Re: **Cherry Tree Condo Hotel P.U.D. (SPR 5-08)**
Submittal Packet Comments

MEMORANDUM

RE: Planned Unit Development for a Spa and Pool at the Cherry Tree Inn (SPR 5-08)

Planned Unit Development and Special Land Use: SPR 5-08, for Cherry Tree Inn

SITE PLAN
 SCALE: 1" = 40'-0"

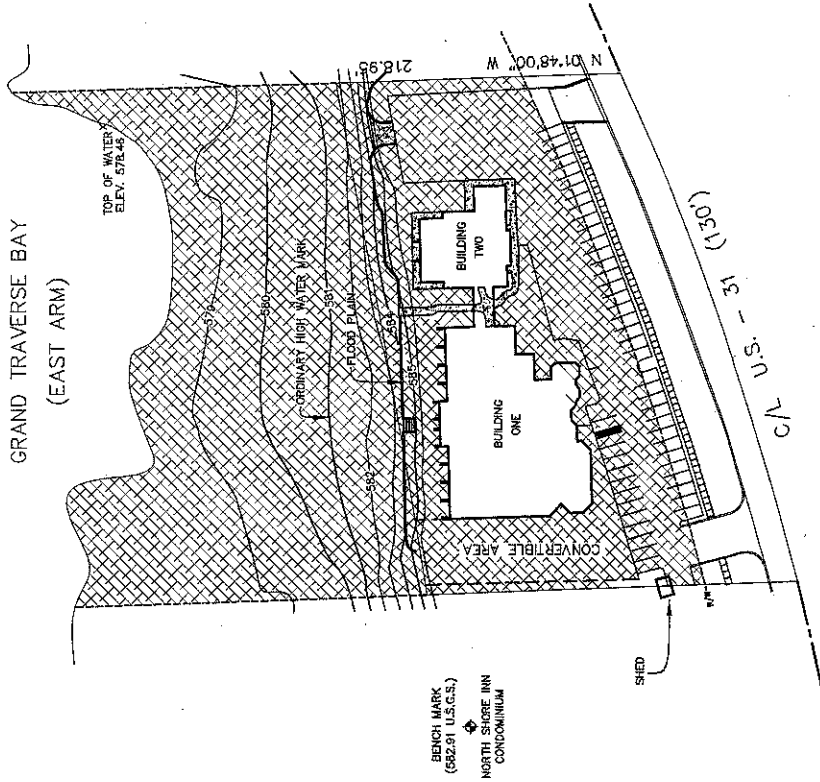
Comment: According to the site plan, there will be 79 parking spaces on site plus two unmarked loading and unloading parallel spaces in front of the building. The angled space adjoining the proposed pool will not be safely usable without a deeper back-out flange to allow an exiting vehicle to reverse out of the space, square-up and exit the lot. The application requests approval of an off-site parking arrangement for 16 parking spaces, to bring the total provided parking to 95 spaces. The applicant has submitted a parking time-use analysis for several days from mid-May through mid-June. It indicates that the current parking lot is most fully utilized overnight, and even when the condominium-hotel is at full capacity, the lot is not full. Further, during the proposed spa hours of 9:00AM to 6:00PM, fewer than fifty of the total parking spaces are occupied. Finally, the applicant indicates that tentative arrangements have been made to lease additional off site parking spaces at Pebble Brook Miniature Golf, located 0.2 miles from the site, and Mount Holiday, located 0.9 miles from the site. Employees would be shuttled back and forth from the condominium-hotel to the off-site parking lots. On July 31, we received copies of letters from Pebble Brook and Mount Holiday agreeing, in principal to this arrangement. However, no binding documentation has been provided.

Comment: The applicant proposes to replace the existing 80 square-foot freestanding sign panel with a sign of the same size and location to identify both businesses. The site plan provided by the applicant indicates that the right-of-way is approximately 152 feet wide, and the replacement sign would be in the same location as the current structure, located behind the sidewalk. The leading edge of the sign scales to approximately 38-feet from the edge of the roadway. Because of the width of the right-of-way and the prior approval of the sign in this location, the Planning Commission may therefore approve this deviation, providing acceptable documentation of MDOT approval can be produced.

2. **Building Width.** In the RB district, buildings situated along the Bay may not exceed 150 feet in width without a view corridor of at least 30 feet in width and at the June meeting the Planning Commission asked that this site plan be reviewed against this standard. The Phase 1 and phase 2 buildings are separated by the required 30-foot view corridor with the permitted second story bridge between them. The 150-foot standard applies to "buildings" and the definition of building refers to structures. Therefore, the addition of the pool with its surrounding "continuous wall/fence" when added to Phase 2 appears to exceed the 150 foot standard. The proposed site plan does not include a description of the pool enclosure and it is recommended that the approval be conditioned on the review of the facility by the Zoning Administrator to assure that the required view corridor is maintained.

3. **Parking.** The parking layout is adequate with the exception of the angled space at the north east corner of the lot. This space may be retained on the plan for a utility vehicle or for other purposes (such as snow storage) but it has such limited utility when the lot is nearly full that we would not recommend it be included in the total parking count. As to the off-site parking arrangements, we suggest any approval be conditioned on the review of the legal arrangements to assure such parking by the Township Attorney.

Based on the parking analysis provided and proposed off site parking agreements, the requested deviation from the ordinance requirements may be appropriate. The only place on the existing site where added parking could be placed is the so-called convertible area along the west side of the building. This area could accommodate a net of about 10 or 11 spaces accounting for the loss of two or three of the existing spaces at the west end of the front lot to accommodate a drive way. If the combination of shared parking and the off-site arrangement can be made to work, this may be preferable to forcing additional pavement if it is not needed. The time-use analysis indicates that that even without the leased off-site spaces it is unlikely the existing lot would be filled during the operating hours of the spa. However, if the approval is to rely on the off-site parking, these arrangements must be memorialized in an agreement that is satisfactory to the Township Attorney.
